## PRODUCT RECALL TECHNICAL BULLETIN

### 9100 POWER AWNING, WEATHERPRO AWNING AND MOTOR SERVICE KITS

April 24, 2013

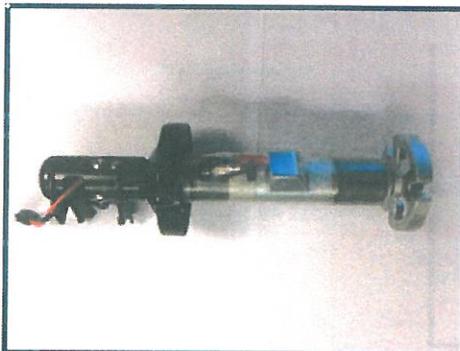
**Background** We recently introduced an enhanced redesign of certain components associated with the motor in our 9100 Power Awning, WeatherPro Awning and Motor Service Kits. There is an important step in our installation instructions which, in conjunction with our design change, **CANNOT BE BYPASSED from the proper sequence (see below, as presented in our instructions).**

5. **WARNING** IMPACT OR PINCH HAZARD. Do NOT remove cotter pin from torsion rod (at end cap) until top casting is secured to front channel. Otherwise, rapid casting spin off will occur. Spring tension will attempt to spin the hardware and/or fabric roller tube quickly and unexpectedly. Failure to obey this warning could result in death or serious injury.

Remove cotter pin from left end of torsion rod (LH end cap). See (FIG. 6).

**Condition** Through on-going testing, we have become aware that in some cases this step is being bypassed during installation. In bypassing this installation step, whether **at your location or at the OEM level**, the 9100 Power Awning, WeatherPro Awning, or Motor Service Kit installation can damage the awning motor. **If this motor damage occurs it is possible that the awning can unfurl unexpectedly, either while the coach is at rest or while in transit.**

**Action** Due to this potential condition, which will not be evident from post-installation inspection, Dometic is requesting that you do not offer any units with an installed 9100 Power Awning, WeatherPro Awning, or Motor Service Kit manufactured within this date range described above. We need you to confirm the serial number of any units that you may have purchased directly from Dometic (which are included on attached document) or any units that may have been purchased from an OEM or OEM distributor (units repaired at the OEM will have a blue or green dot on the right hand motor end-cap). We have provided the attached visual depiction of the affected motors for your convenience. **We are providing a letter (attached) for YOU to send to your customer** requesting that they should **NOT DRIVE their vehicle** until they have called the number provided in that customer letter. We will be making contact with each dealer to support the replacement and quarantine of these units. If you have confirmed a serial number, as outlined, then please call **1-888-447-0003**. We will provide detailed instructions during this call.
